## Wolli Creek Preservation Society Inc.

The Wolli Creek Preservation Society has a new compromise proposal to offer in relation to Sydney Water's proposed Odour Control Unit in Wolli Valley.

The proposal has become possible because of information obtained from Sydney Water under GIPA legislation. While the key information sought was redacted, and we have numerous detailed objections to the site comparison reported, the Site Assessment Technical Note released to us nonetheless provided sufficient information to enable this new proposal to be developed.

**Diagram 2 - Option A**  
**Sydney Water's original site proposal**  
**showing the wider context and nearby**  
**residences to E and NW**

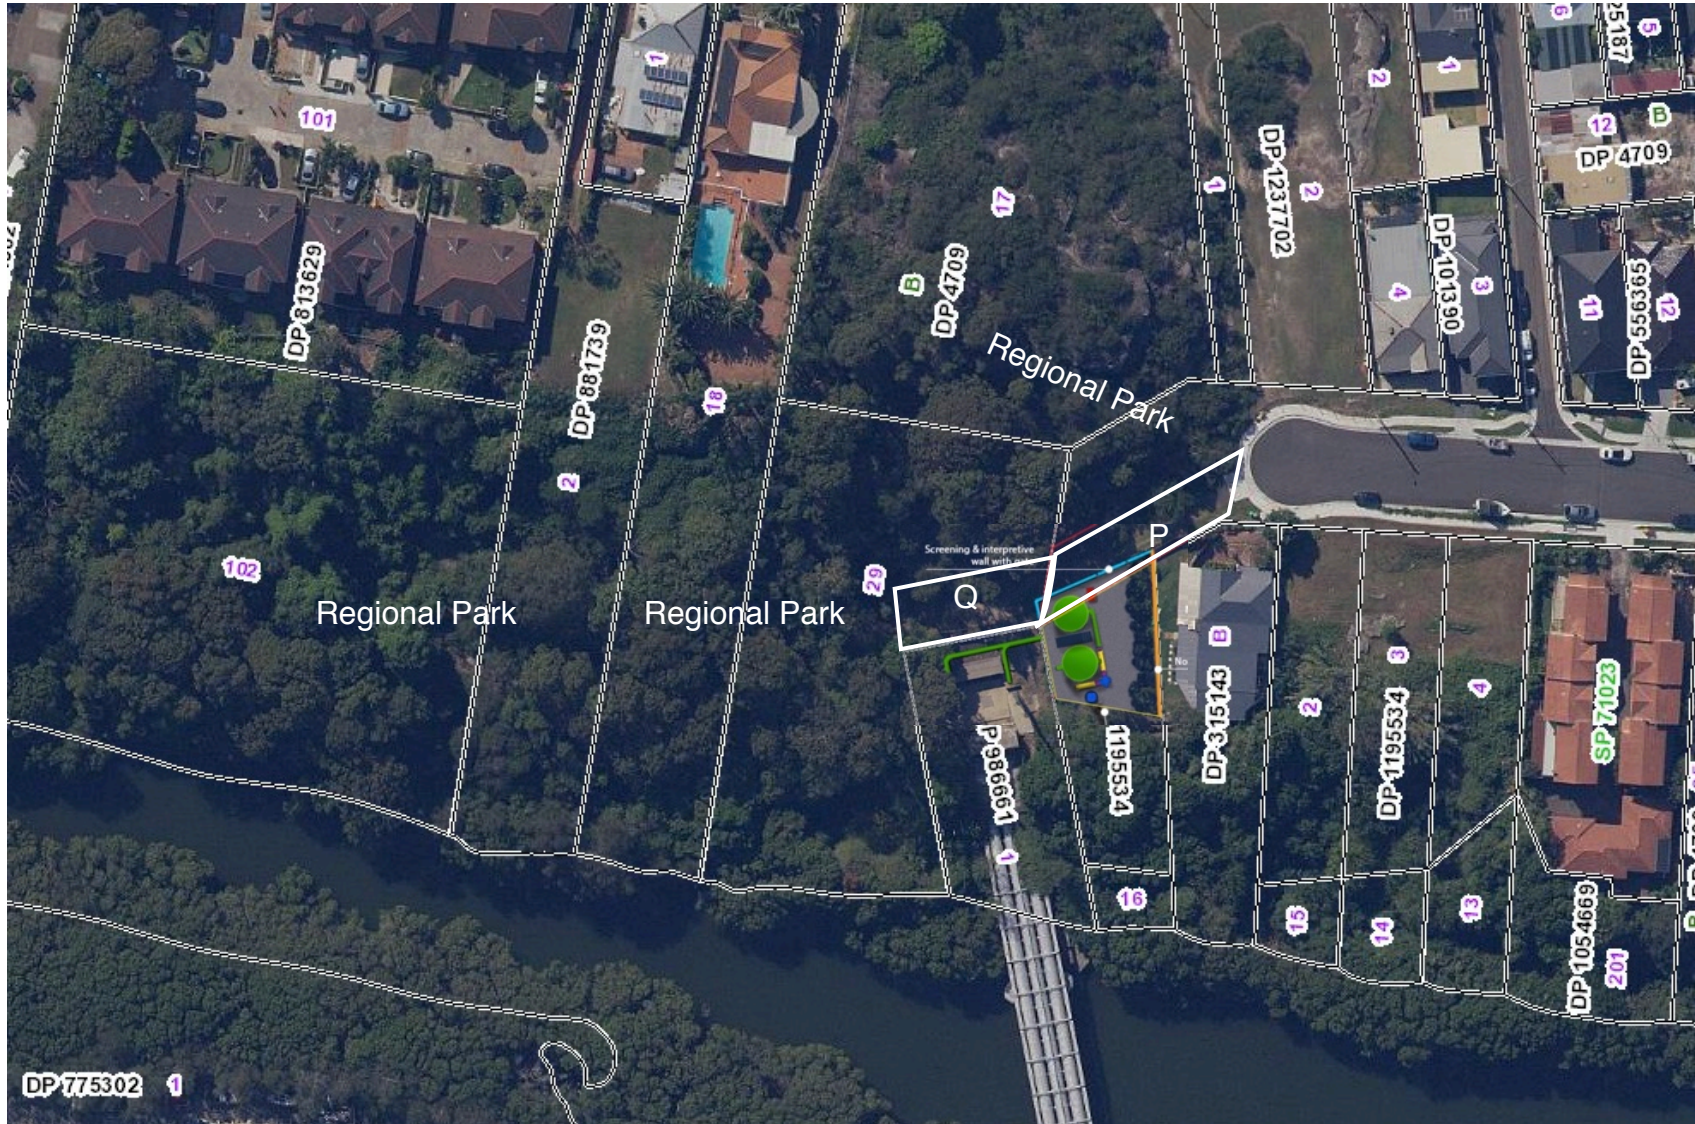
- The impact on No.20 Unwin St from our alternative site is made unbearable by the awkward E-W orientation that Sydney Water chose for siting the OCU.
- Even with that E-W orientation, the alternative site is actually preferable to the original one, apart from the impact on No.20.
- WCPS has a new proposal that significantly reduces the impact on No.20.

**Diagram 3 - Option W**  
**Wolli Creek Preservation Society revised proposal**  
**for the alternative site**  
**showing the wider context and nearby residences**

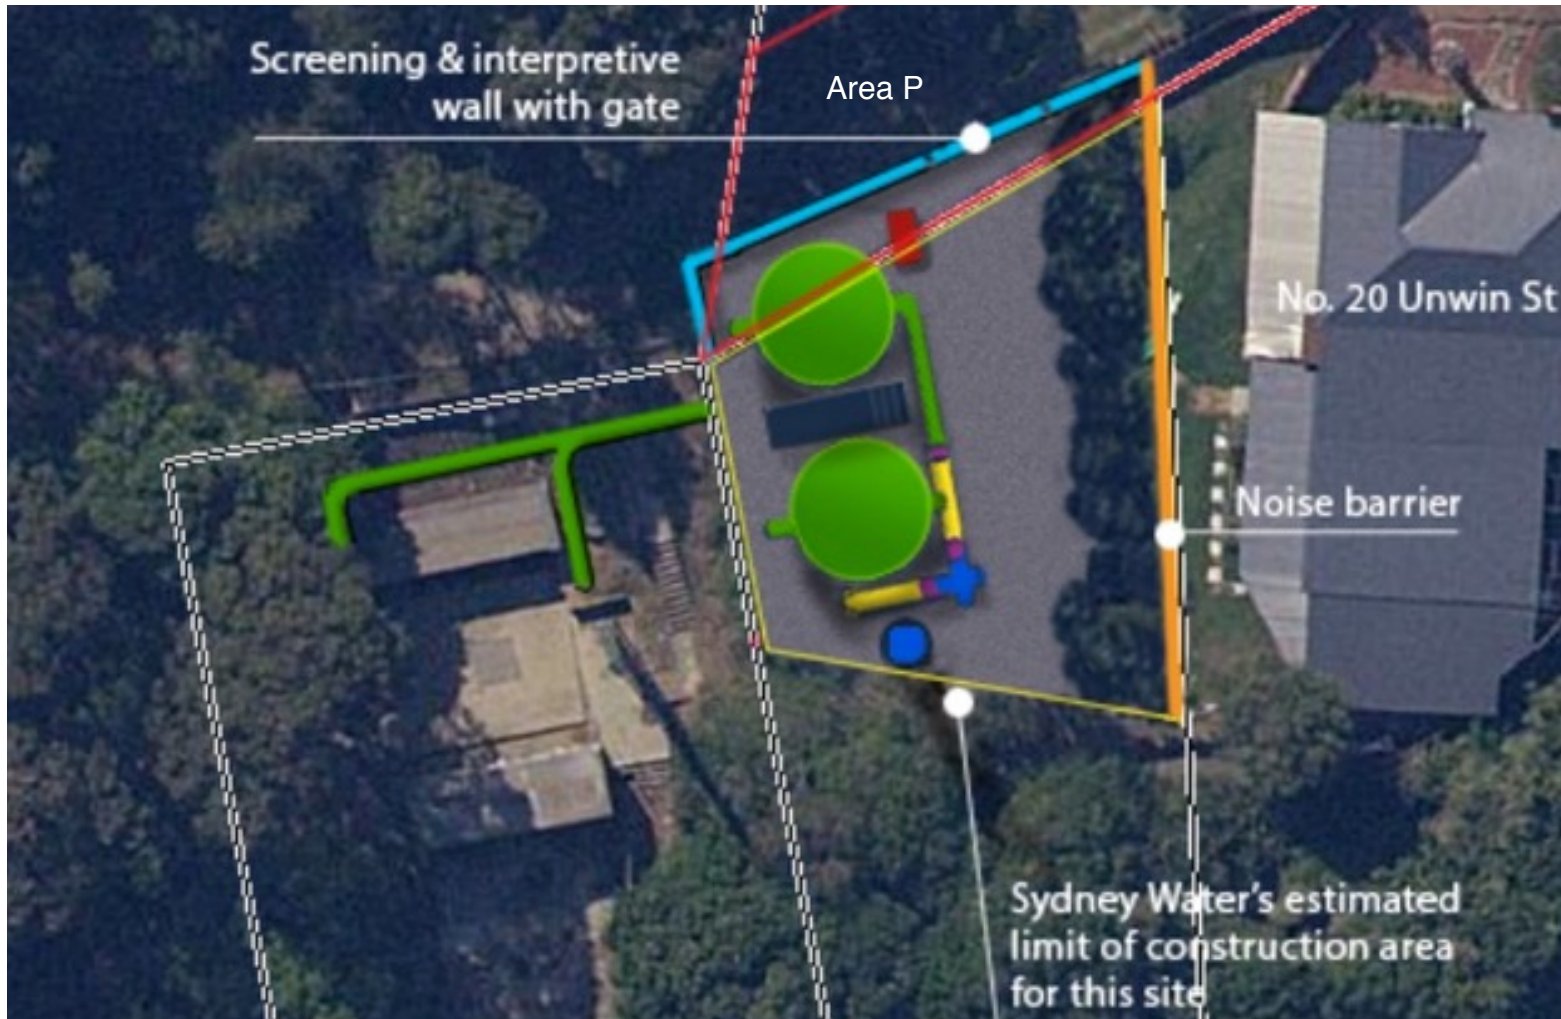
Our new proposal is a positive contribution that resolves the concerns that WCPS has while overcoming many of Sydney Water's. The new proposal:

- still makes use of No. 22 Unwin St (WCPS's alternative site)
- **does not require the acquisition of No.20 Unwin St**
- stays essentially within the restricted area identified by Sydney Water as suitable for construction of the OCU (shown on Technical Note p6)
- uses only the same design elements identified for Sydney Water's own site, and has the exhaust pipes crossing the SWOOS site at the same point
- **significantly increases the separation of the OCU from the residence at No.20**
- **allows for vegetation screening and a sound barrier between the OCU and No. 20**
- provides better screening from the OCU for the heritage listed SWOOS
- provides for the maintenance crane a hardstand that is off-track (off the pathway shared with the Two Valley Trail)
